STANDARD-TRIUMPH MOTOR COMPANY, INC.
NORTHEASTERN ZONE

BULLETIN: T-62-27

DEPT: SERVICE AND PARTS

TRIUMPH TR-3 SEAT BELT ANCHORAGE DRILLING TEMPLATE DESIGN

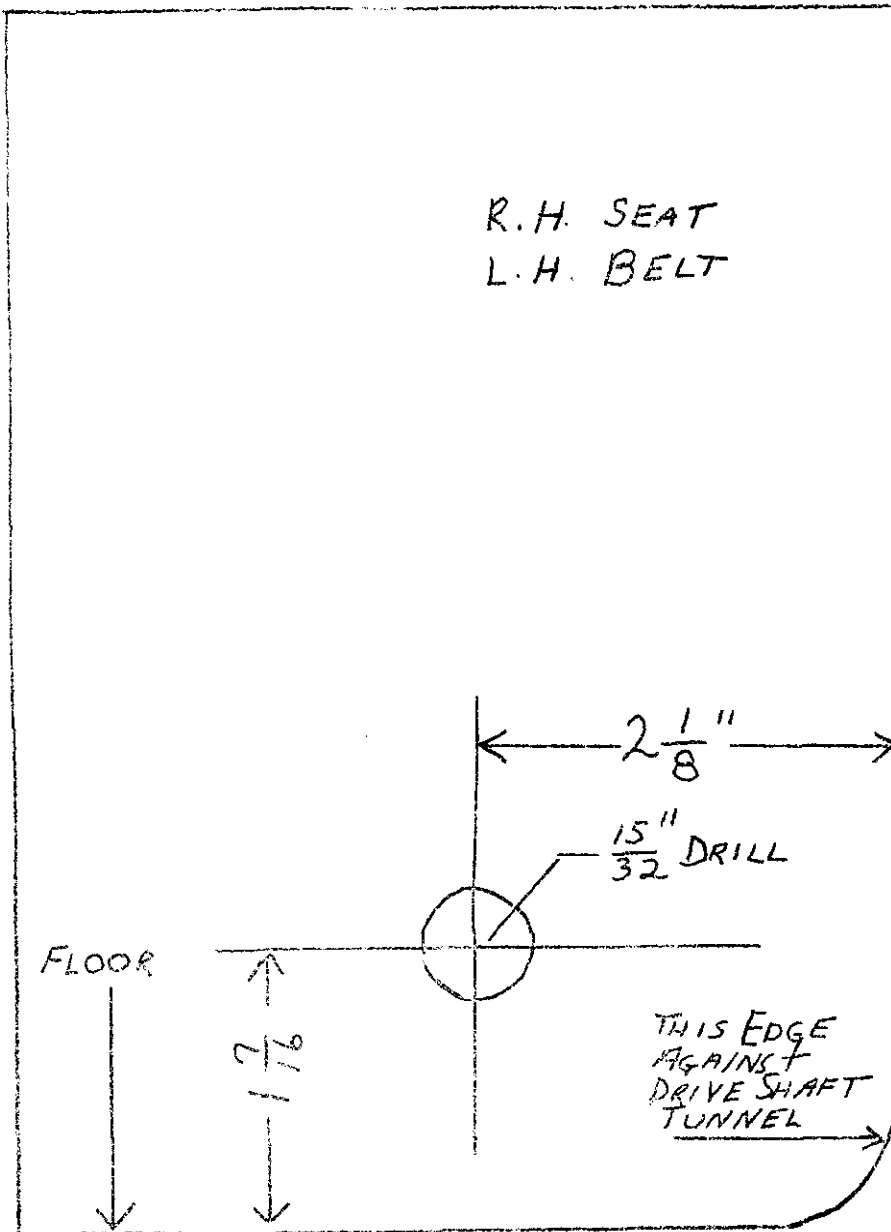
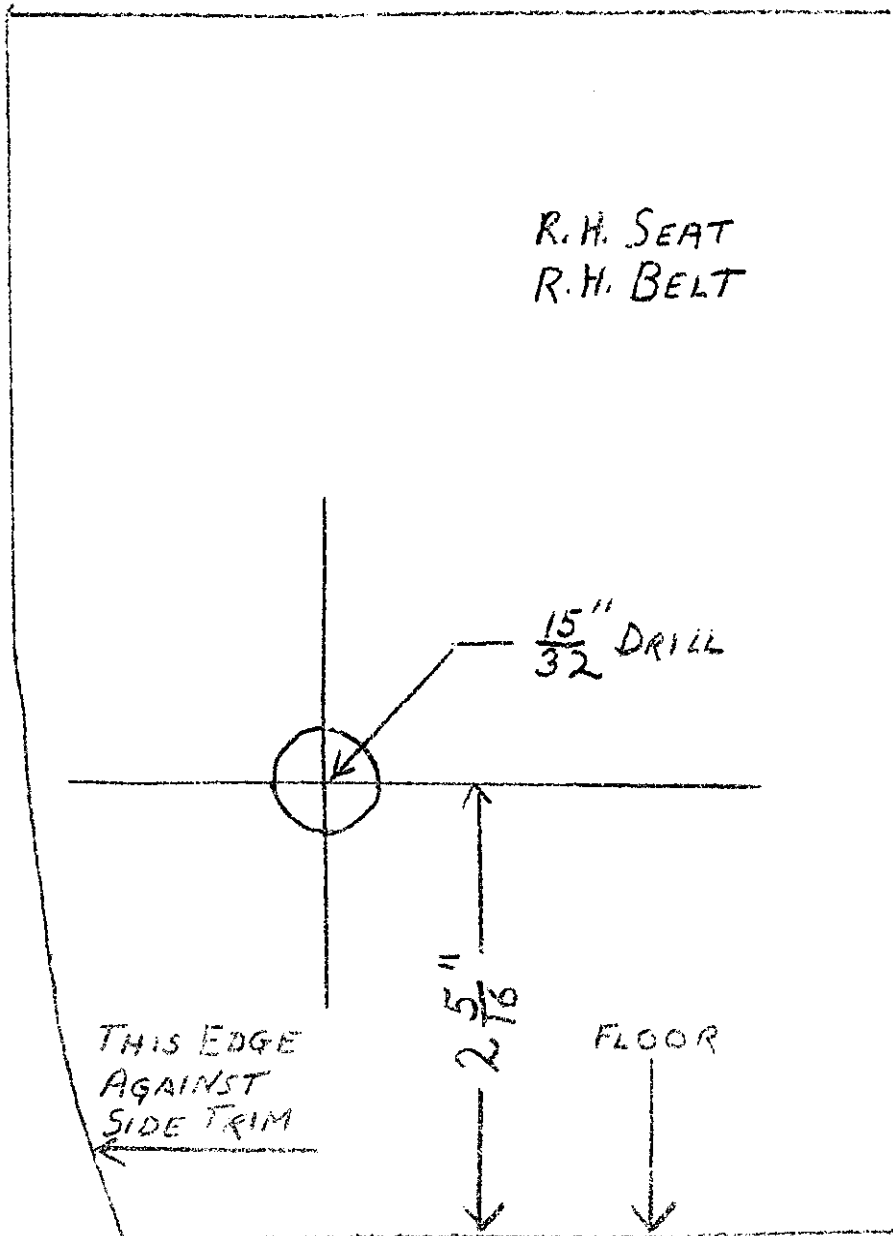
As an enclosure you will find drawings for drilling template design for mounting seat belt anchorage belts in the TR-3. As with the Herald model, it is anticipated that these templates will only be necessary for modification of cars in dealers stocks in the State of Connecticut.

While it is felt that these drawings are self-explanatory, it should be pointed out that, when using the templates, you should place them vertically against the heel board of the rear seat platform and thereby make the actual drilling and anchorages through the heel board. You will find also that by reversing the templates, you can locate anchorage points for both the left and right sets of belts.

INNER AXLE SHAFT
(MODIFIED CIRCLIP GROOVE)

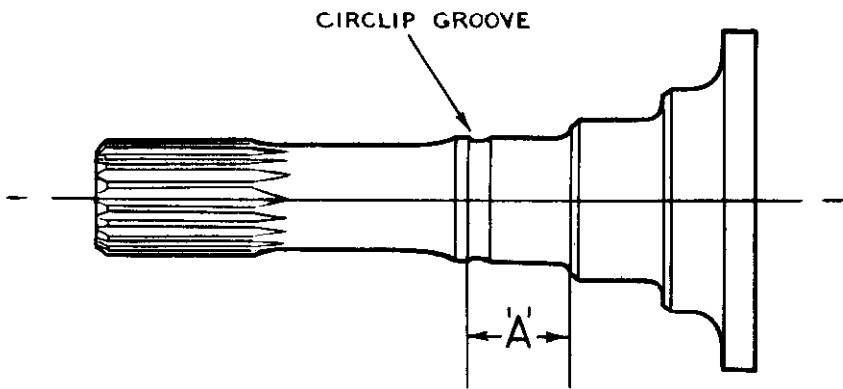
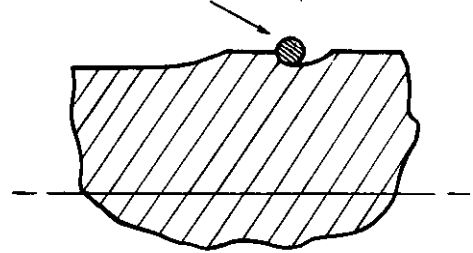
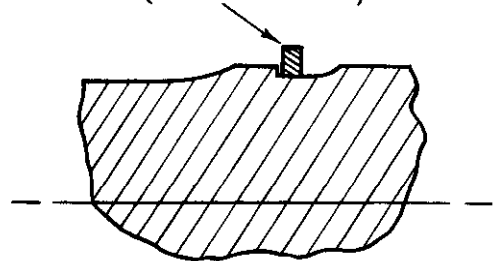
Inner half shaft rear axle assemblies of units from commission numbers GA-35604 and Y-31501 incorporate a revised circlip groove. These shafts may be used to replace the earlier type, provided that the revised circlip is also fitted and the existing thrust washer discarded.

The enclosed illustration will assist in the identification of both the new and old type shafts.

PART No. 132649 — DIM. 'A' 0.643"/0.648" (16.33/16.46mm)
PART No. 117661 — DIM. 'A' 0.683"/0.685" (17.35/17.40mm.)

EXISTING ASSEMBLY.

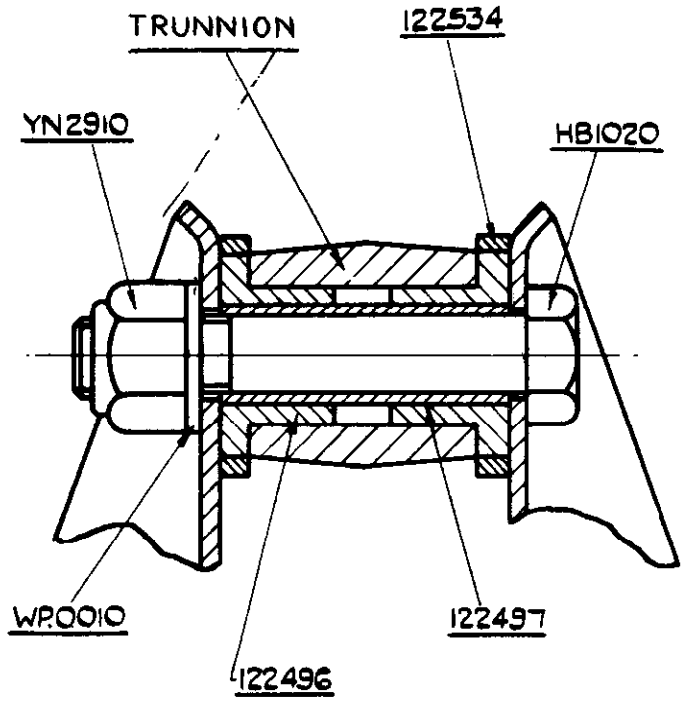
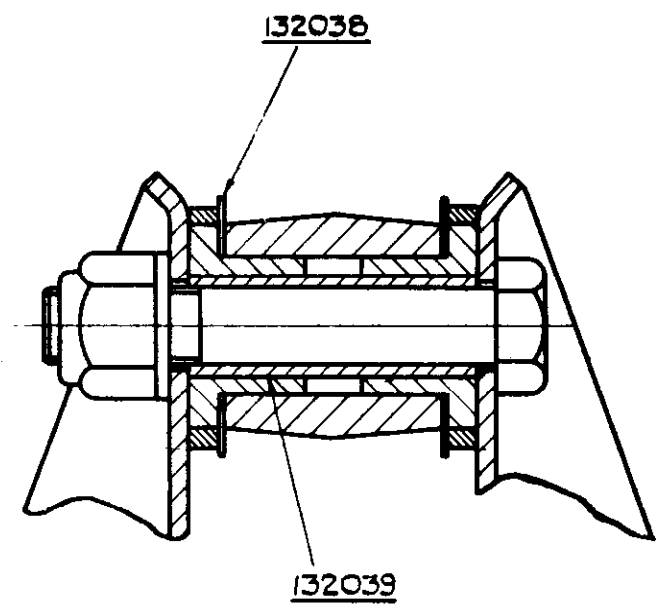
To improve the sealing and prevent premature wear of the bushes of the front suspension lower trunnion, shims have been added to the assembly as shown in the illustration.

When the occasion arises to renew the trunnion bushes these shims should be added, which necessitate replacement of the distance piece Part No. 132039 in place of the original distance piece Part No. 122497. The fitting instructions are as follows:

1. Remove hex. nut YN2910 and washer WP0010. Withdraw hex. bolt HB1020.
2. Remove distance piece 122497, bearing 122496 and seals 122534 from lower trunnions.
3. Reassemble above items as follows:

Fit shims 132038 between bearings 122496 and lower trunnions as shown in modified assy.
4. Fit distance piece 132039 in place of 122497. Fit seals 122534.
5. Reassemble and insert hex. bolt HB1020.
6. Replace washer WP0010 and hex. nut YN2910.

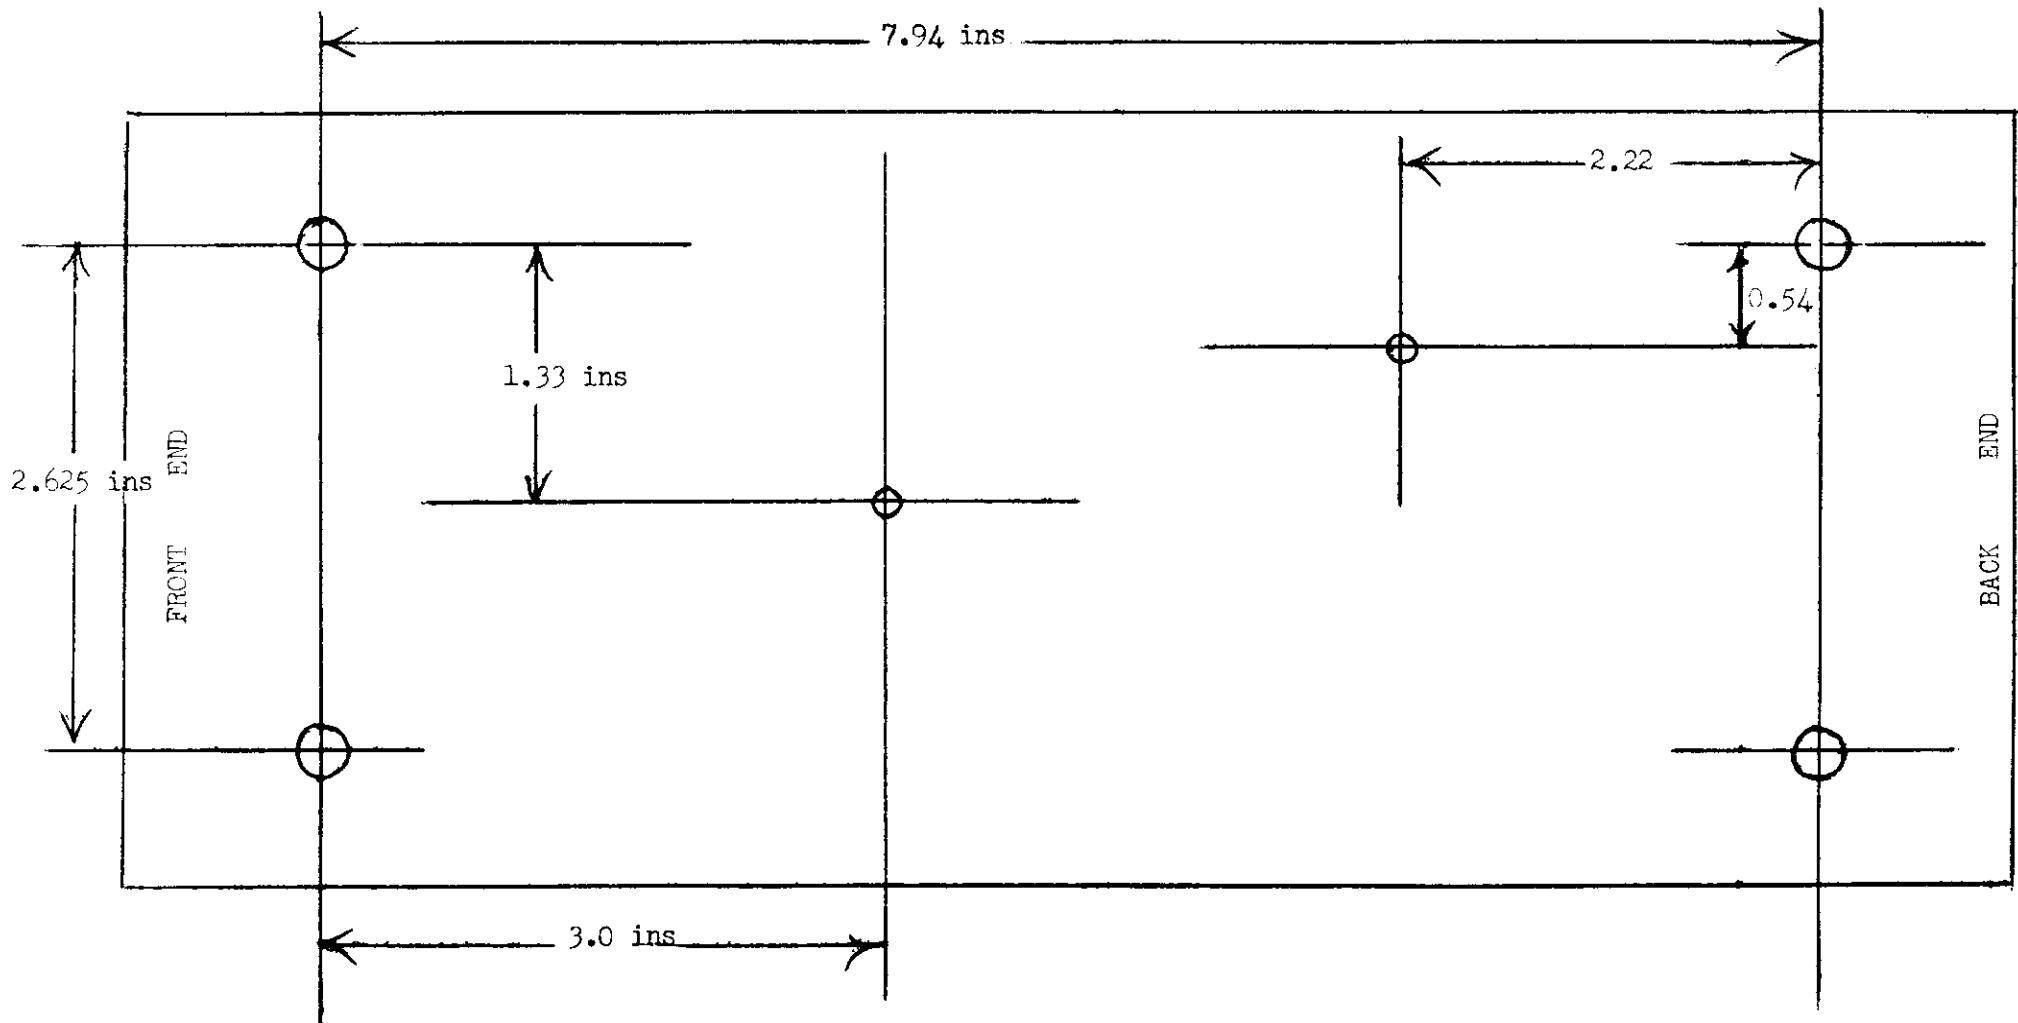
On earlier cars the holes for the two switches will be found already drilled and no difficulty will be experienced in removing the plugs and inserting the switches. However, on newer models these holes have not been drilled and a jig can be made to facilitate the positioning which is not necessarily in the center of the boss on the casting.

The template, shown on the attached sheet, can be made from thin metal plate and is latched on the position top extension with the two holes corresponding to the attachment stud holes. When pushed through the small holes in the template will then locate the drilling position for the isolator switches.

The switch holes can be drilled and tapped using a 17/32" drill and a 16 size tap. It will be necessary, however, to remove the selector rods etc., from the expansion prior to drilling in order to avoid damage and to enable the resulting metal particles to be thoroughly cleaned away.

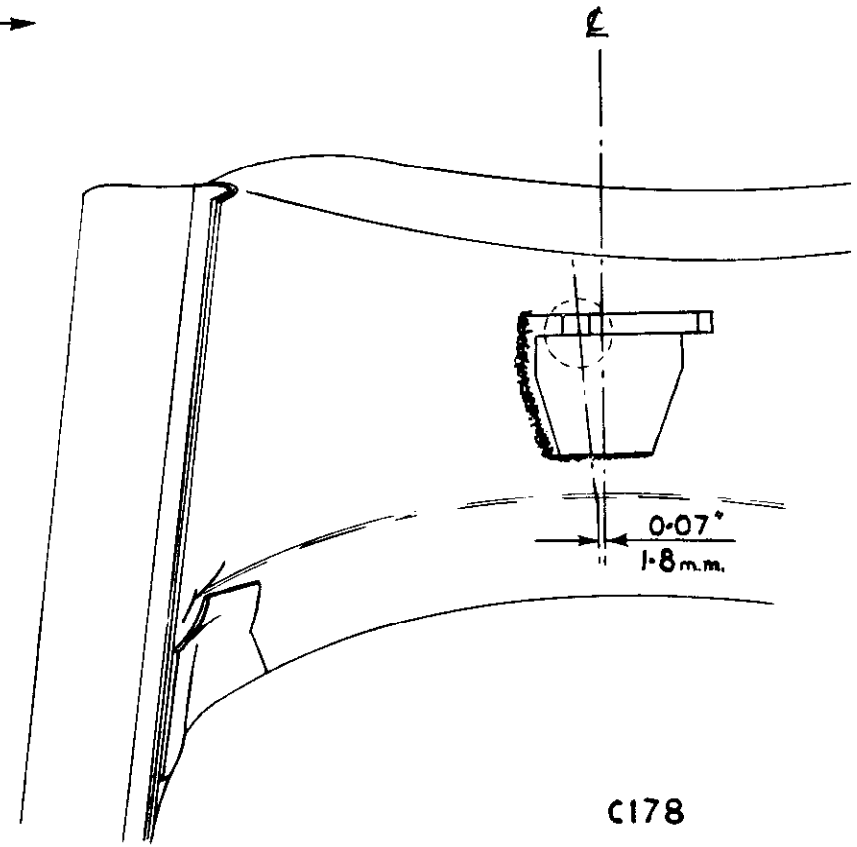
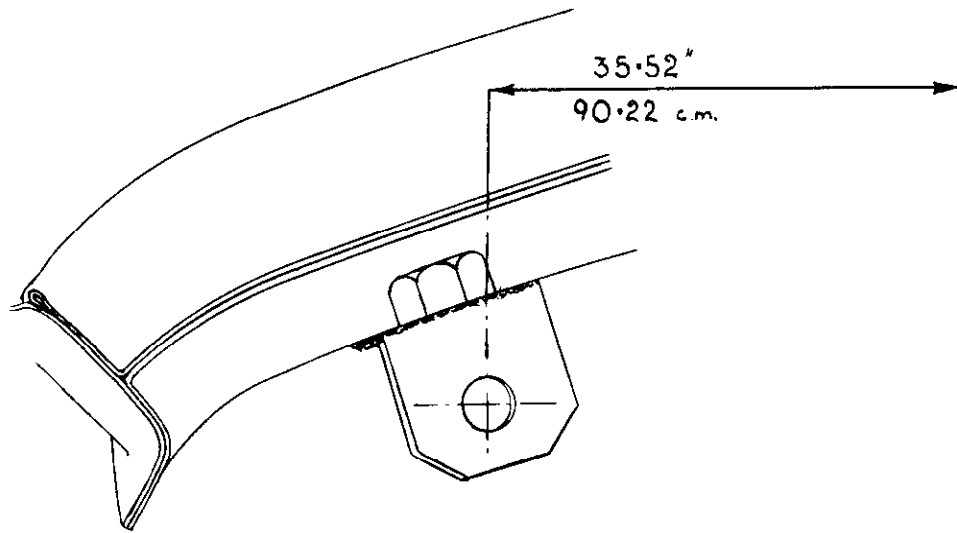
Minor modifications to the existing windscreen header panel are necessary when fitting a later type roof to early models.

Position the bracket as illustrated and gas weld it securely to the header panel.

The roof panel is secured to the brackets (2) using clamp bolts, washers and tapped plate (3,4 and 5).

File all welding burrs from around the fixing holes in the windscreen header panel.

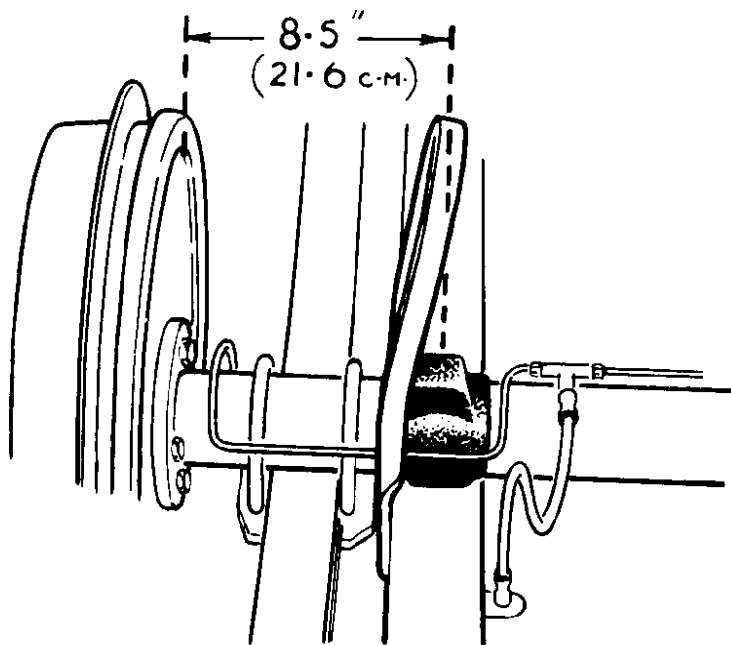
Under full bump conditions, unless this bump control strap is in the correct position, it is possible for the control strap to foul the brake pipe from the three-way connection to the offside rear wheel cylinder.

When checking the bump control strap, it is IMPERATIVE that inspection be made of brake pipe part #208286 which leads from the three-way connection to the right rear wheel brake cylinder. It is important to do this as it is possible there is already damage to the brake tube at the point where the brake tube leads from the three-way connection. It will be necessary to remove the brake pipe part #208286 to inspect the pipe for damage which may already have occurred and which ordinarily would be concealed by the pipe nut.

We are attaching a drawing showing the proper location of the bump control strap and the pipe nut on the three-way connection which must be unscrewed in order to check the brake pipe which leads from the three-way connection to the right rear wheel brake cylinder.

BOSS TAPPING DETAILS.

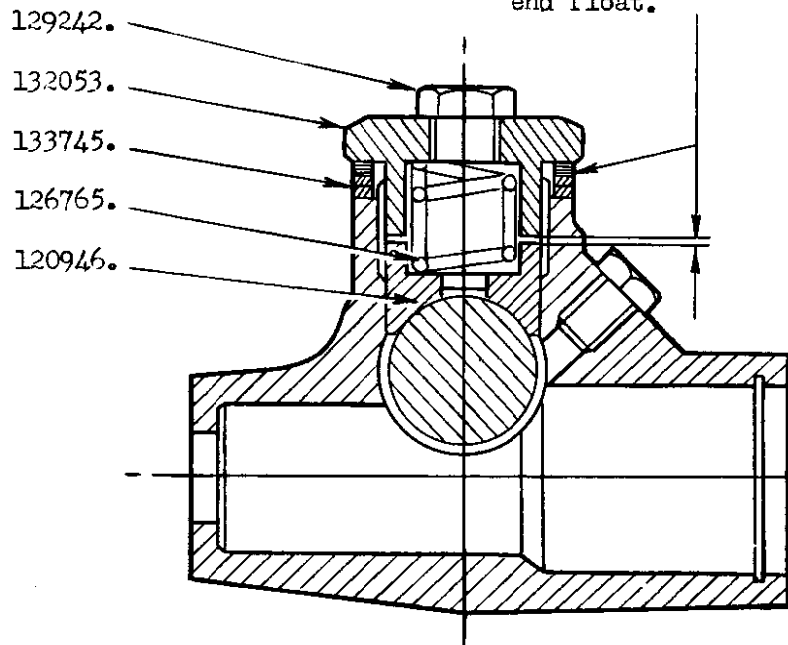
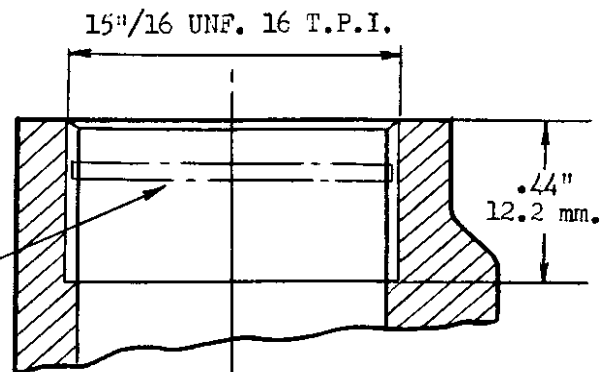
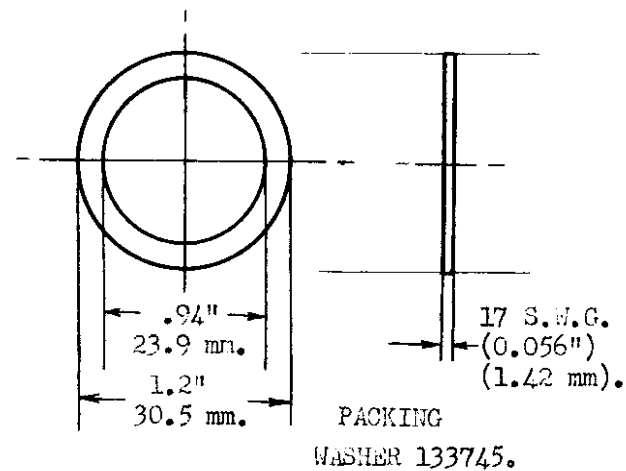
1. Remove and dismantle the steering unit as described in the Service Manual (Group 4).
 2. Tap the plunger boss housing to a depth of $\approx .44$ " (12.2 mm) using a 15/16" UNF. 16 TPI tap.
 3. Thoroughly clean the housing and pack with the correct grade of grease when refitting the rack and pinion.
 4. Fit new plunger 120946; spring 126765; and screwed cap 132053; placing two packing washers 133745, and sufficient shims 120949 and 120959 between the cap and housing to obtain correct end float.
- NOTE: The end float should be between .004" to .008" (0.1 to 0.2 mm) or the minimum amount consistent with free movement from lock to lock.
5. Refit the steering unit.

This method of securing plunger may be incorporated on Part Number 205628 and 304737 when serviced for complaint of circlip not holding in position.

Use shims 120949 and 120959 as required to give 0.004" - 0.008" (0.1- 0.2 mm.) plunger end float.

Bearer plate thickness increased
from 0.128" to 0.160"

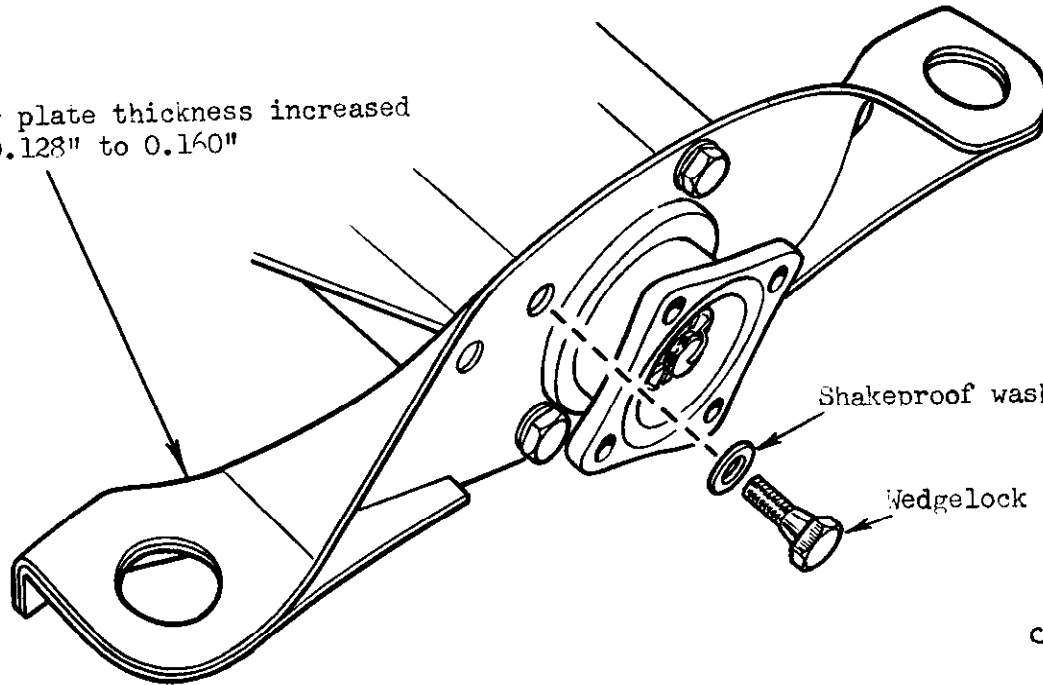
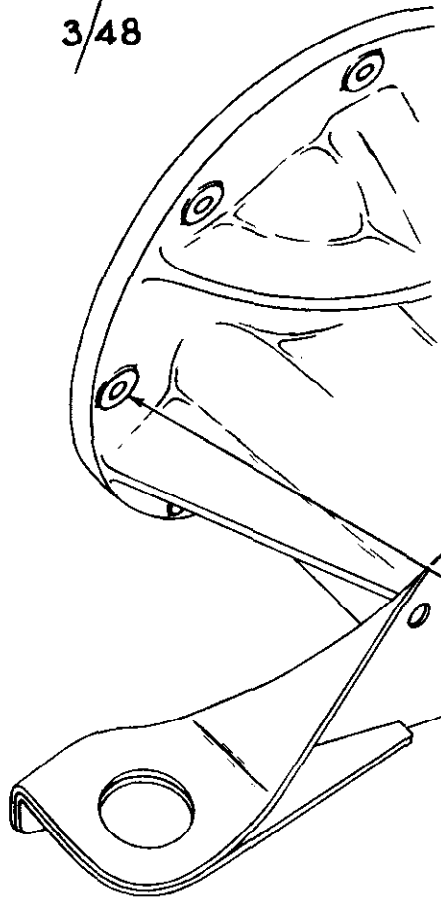
At some time between 1965 and 1967 the thickness of the bearing plate was increased from 0.125" (3.175mm) to 0.160" (4.064mm). At the same time the wedglock set screws were modified by increasing the taper to accommodate the extra bearing plate thickness. This permits the tapered neck to ENTER the tapered hole of the nose piece more deeply than before, thus more effectively locking and locating the bearing plate and nose piece.

Therefore, when rectifying a complaint of loosened setscrews, fit the modified type (Part Number 132856), tightened to a torque of 34-36 lb. ft.

Fit two short setscrews
 $\frac{3}{4}$ " long Part No. (124717)
to attachment flange with-
out bosses at this point
and the opposite side.
